SUMMARY OF CONCERNS IN RELATION TO THE PROPOSED NORTHCONNEX TUNNEL

This is an objection to many aspects of the proposed NorthConnex tunnel.

SECTION A: THE CONNECTIVITY OF NORTHCONNEX SOUTHERN VENTILATION FACILITY AT THE SOUTHERN INTERCHANGE, THE SOUTHBOUND TUNNEL IN PARTICULAR

Figure 5-17 Motorway operations complex

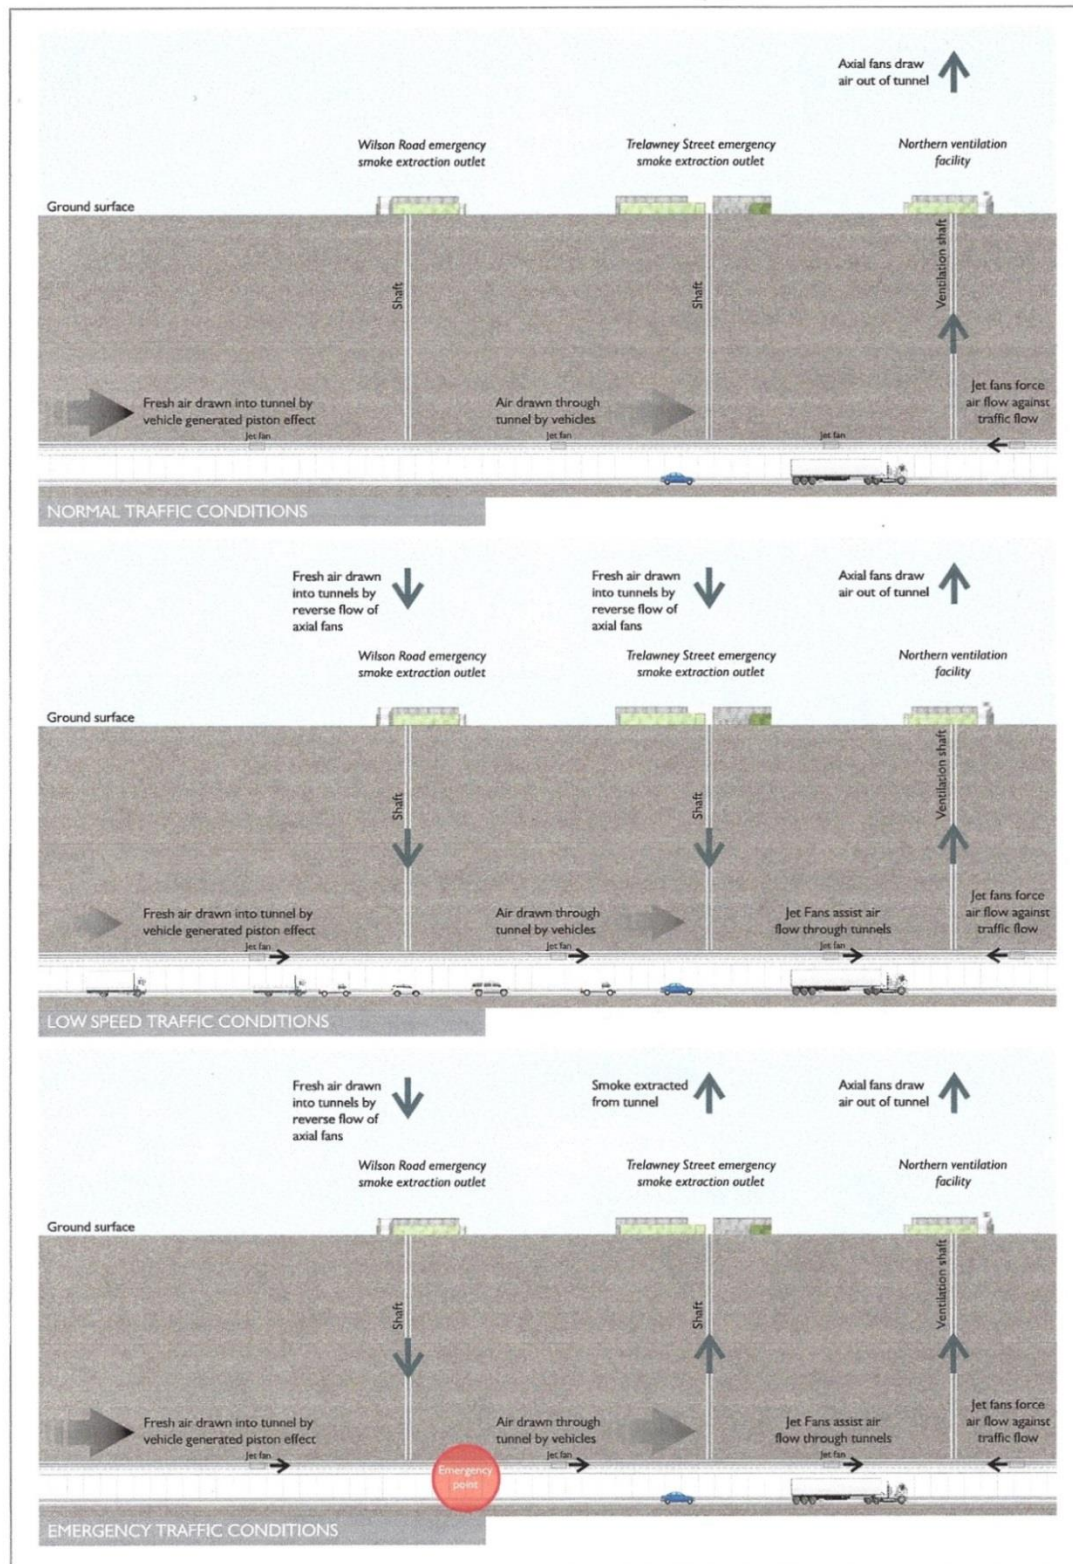
EIS Page 111, *Figure 5-17 Motorway operations complex*

Page 8 below there is no indication of how the ventilation facility will be connected to either the northbound or southbound tunnel, nor is there any indication of how the southbound exit portal onto Pennant Hills Road or the south-west exit portal onto the M2 will be connected.

In each of the above figures for Wilson Road, Trelawney Street, and Northern Ventilation facility, the shafts, emergency smoke extraction buildings, and ventilation facility make a substantial footprint in the construction area; however for the Southern Interchange the ventilation facility is an insignificant part of the construction area. How can this be? The difference in scale does not explain the difference.

We also find it disturbing that in each of the above figures for Wilson Road, Trelawney Street, and Northern Ventilation facility the headings are for “*tunnel support facility operational layout*” and “*ventilation facility operational layout*” but for the Southern Interchange the description is for “*Motorway operations complex*” with no mention of the ventilation facility or the tunnels.

Figure 5-38 Indicative southern interchange construction compound

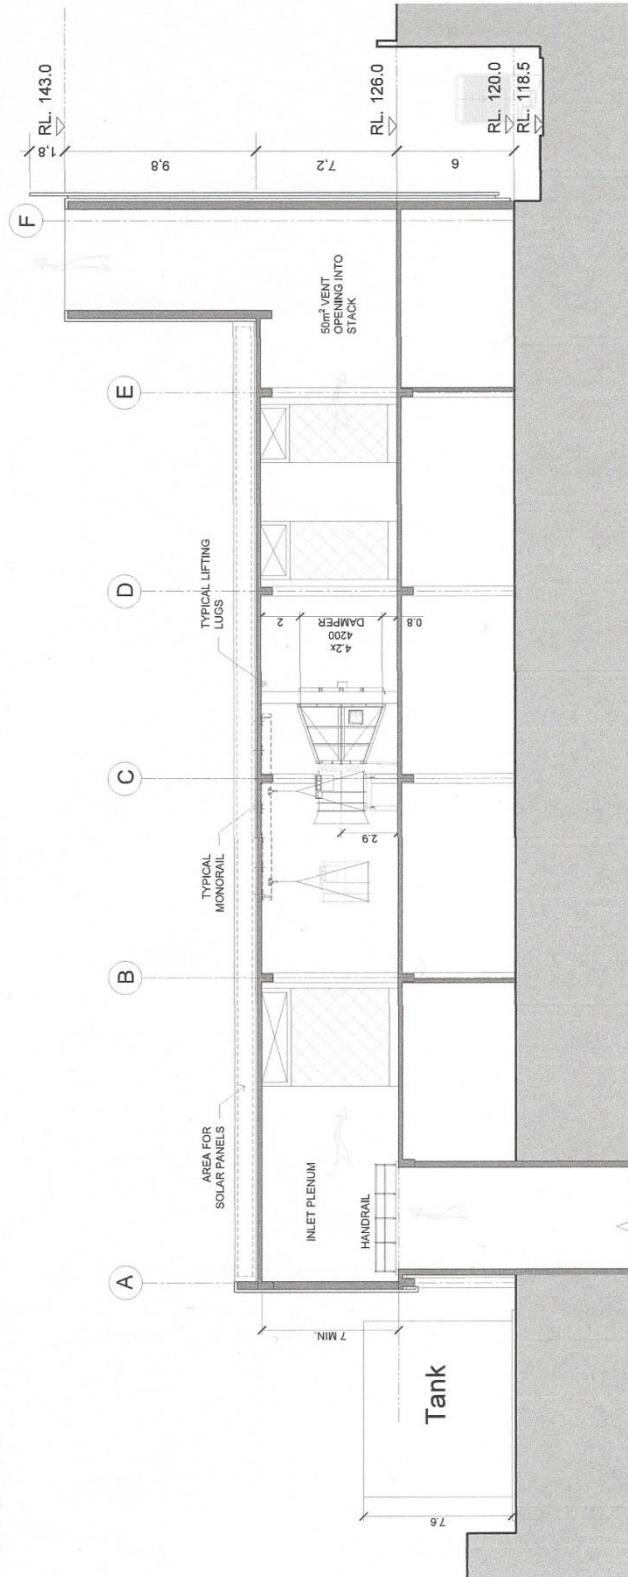
3. EIS Page 189 *Figure 5-38 Indicative southern interchange construction compound* *Page 9 below*

It is ominous that the southern ventilation facility and shaft are completely absent from Figure 5-38.

MOTORWAY OPERATIONS COMPLEX - SOUTHERN VENTILATION FACILITY - SECTIONS
M1-M2-5000-DR-JD-0525

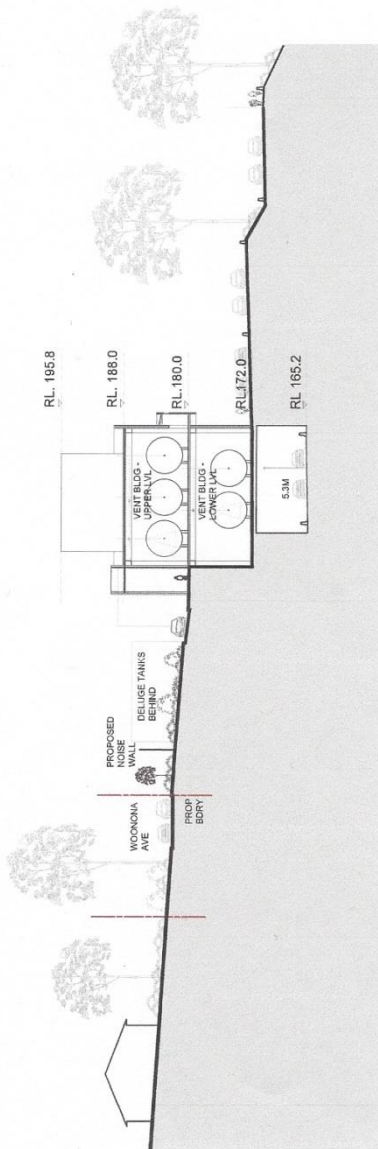
5. *EIS Volume 4, Technical working papers - Urban Design, 6.0 Operational Ancillary Facilities*
EIS Page 99 there is the diagram "Motorway Operations Complex – Southern Ventilation Facility – sections. *Page 10 below* The diagram has the cryptic label "Connection to tunnel TBC". What does TBC stand for? To be considered? Why is tunnel singular? Which tunnel is the diagram referring to northbound or southbound? There is no diagram showing any connection from the Southern Interchange ventilation facility to either the northbound or the southbound tunnel in any way AND YET

- Diagrams need to be provided showing the inter-relation between the shaft, the ventilation outlet and the motorway operations centre with a clear description of what is to be constructed and how it will operate.
- The community needs irrefutable evidence that the polluted air from the southbound tunnel exit portals will not be allowed to flow like an invisible sewer through West Pennant Hills, North Rocks, Carlingford and Beecroft.

MOTORWAY OPERATIONS COMPLEX - SOUTHERN VENTILATION FACILITY - SITE SECTION 1-1
M1-M2-5000-DR-UD-0713

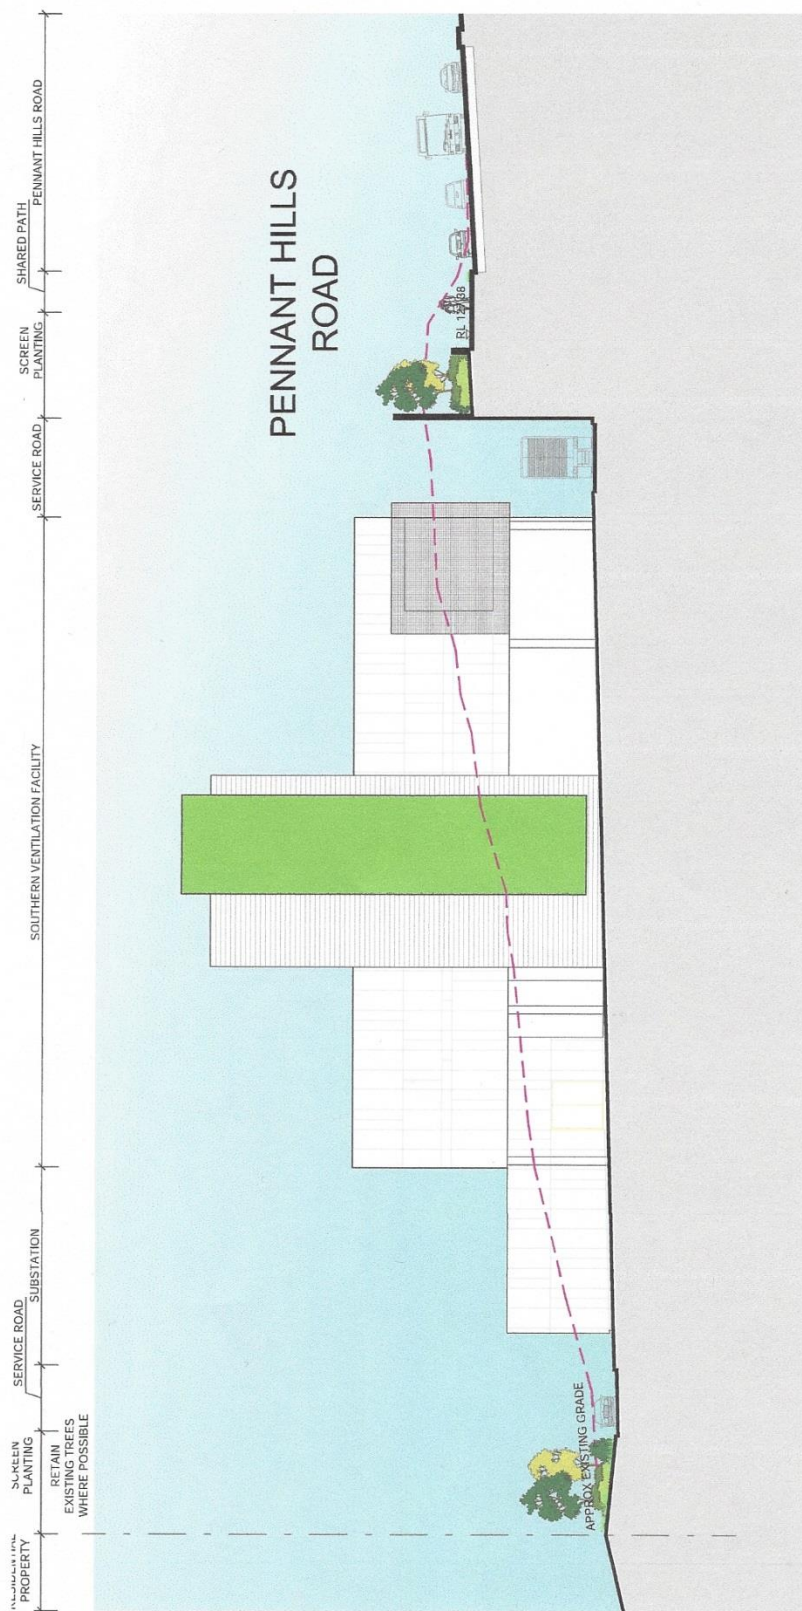
6. *EIS Volume 4, Technical working papers Urban Design, 8.0 Landscape Design*
EIS Page 176 is the diagram "Motorway Operations Complex – Southern Ventilation Facility – Site 1-1". *Page 13 below* The diagram does not show any connection to either the northbound or southbound tunnel. In the same Landscape Design section, EIS Page 182 is the diagram "Wilson Road Tunnel Support Facility –Section" *Page 14 below* which clearly shows the connection to the tunnels. In the same Landscape Design section, EIS Page 189 is the diagram "Northern Ventilation Facility – Landscape Concept Section". *Page 15 below* This also clearly shows the connection to the tunnels.
